Revision History

Design By	carlos	Approve By	Kevin Lai
Date	2019/11/20	Date	2019/11/20
Title			
MSR			
Size	Document Number		Rev
	B8S main board		2.0
UIC Uniform Industrial Corp.		Sheet	5 of 8

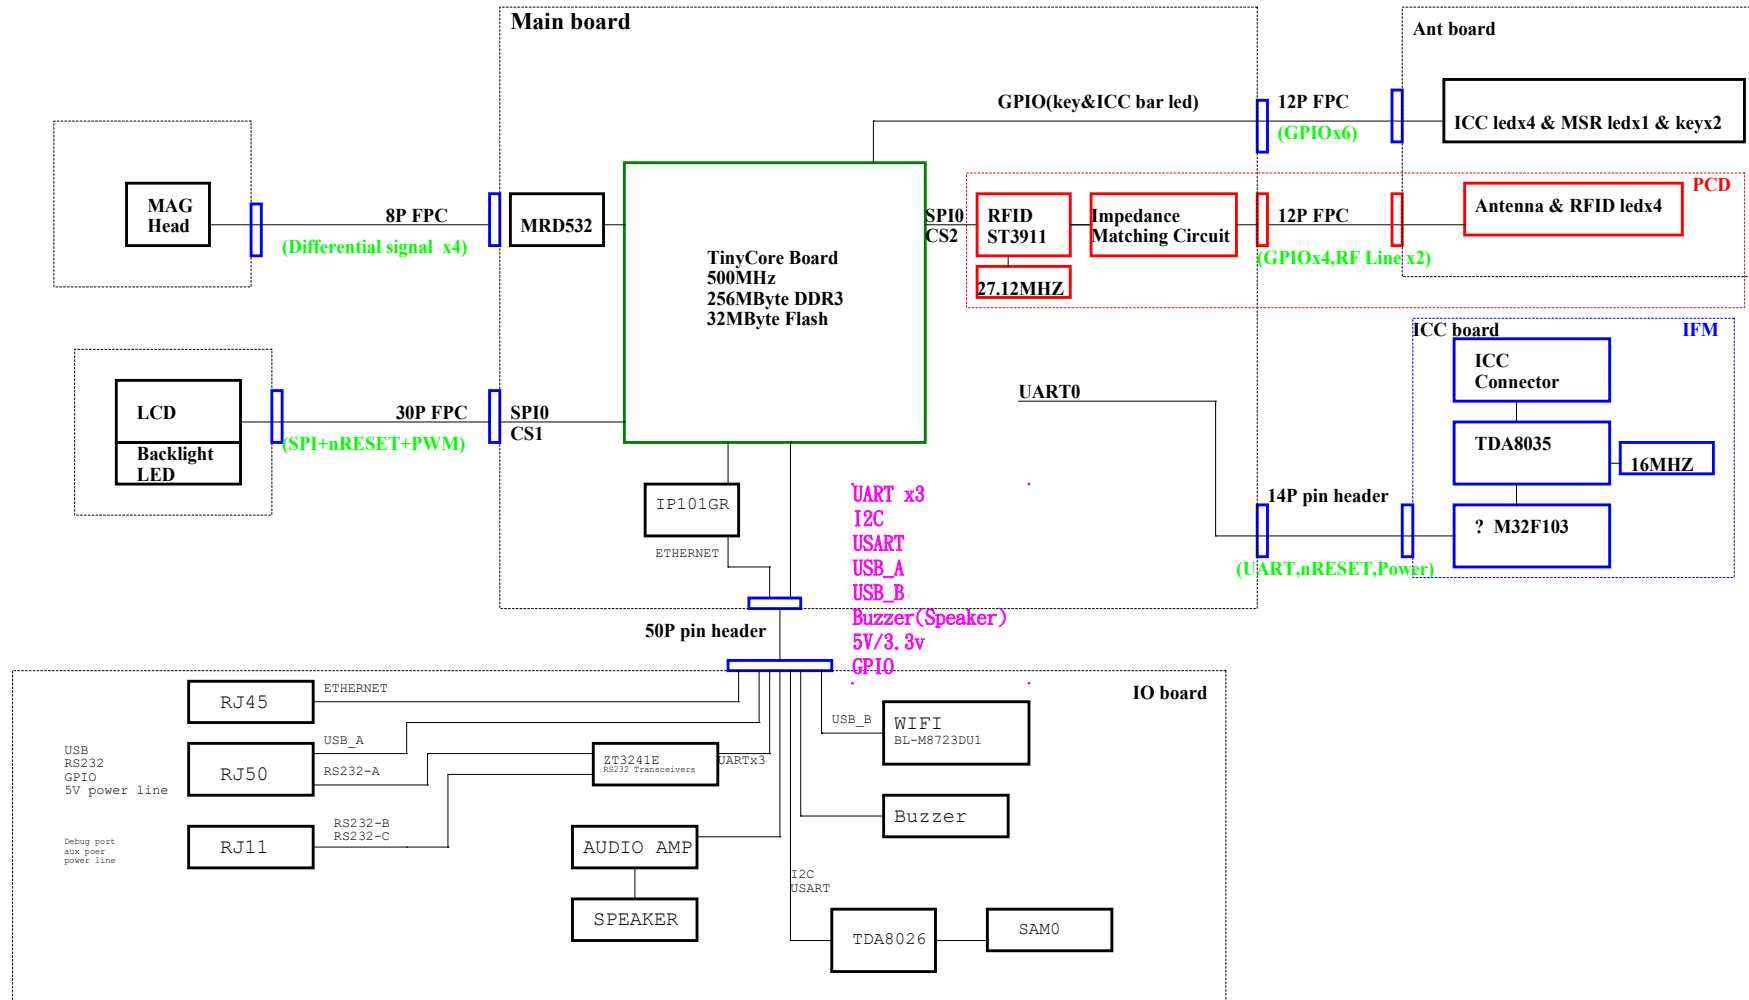
Rev. Code	Date	By	Description
1.0	2019-07-23	carlos	1 release Rev 1.0 to layout
2.0	2019-11-20	carlos	1 release Rev 2.0 to layout
A	2021-01-09	Gary	For EMV3.0: C17,C24 from 220pF change to 180pF(CCA181J610-R) Del C20,C26 C22 from 220pF change to 15pF(CCA150F610-R) C32,C35 from 39pF change to 68pF(CCA680J610-R)
A.1	2022-10-05	Gary	Update Schematic for TQM. Main Board Y1,C29,C31,R35 from PART B1 change to PART A ECR change TQM BOM description.
